Change Subclause 100.2.9 to the following. Remove all previous subclause headers under 100.2.9:

100.2.9 CNU transmitter requirements

Figure 7-1 - Time references for OFDMA symbol and Superframe

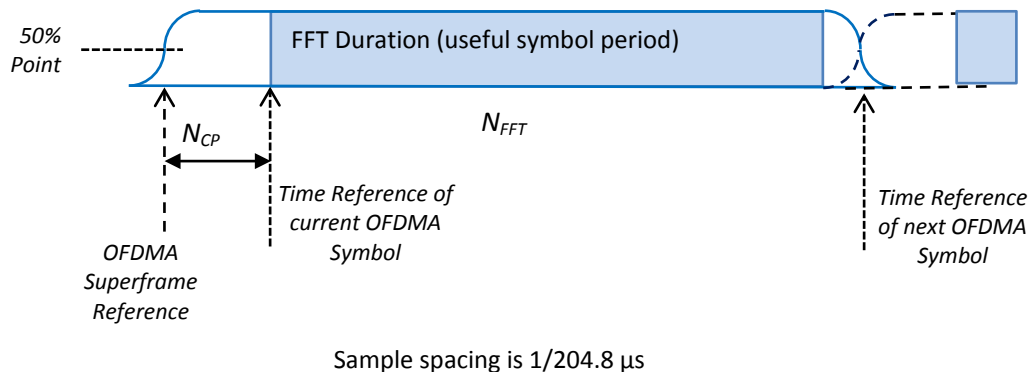
The upstream time reference is defined as the first sample of the first symbol of an OFDMA Superframe, pointed to by the dashed arrow of Figure 7-16. The parameter N_{FFT} refers to the length of the FFT duration of 4096, and the parameter N_{CP} is the length of the configurable cyclic prefix. The sample rate is 204.8 Msamples per second.

The upstream time reference for construction of each OFDMA symbol is defined as the first sample of each FFT duration of each OFDMA symbol, pointed to by the dotted arrow of Figure 7-16.
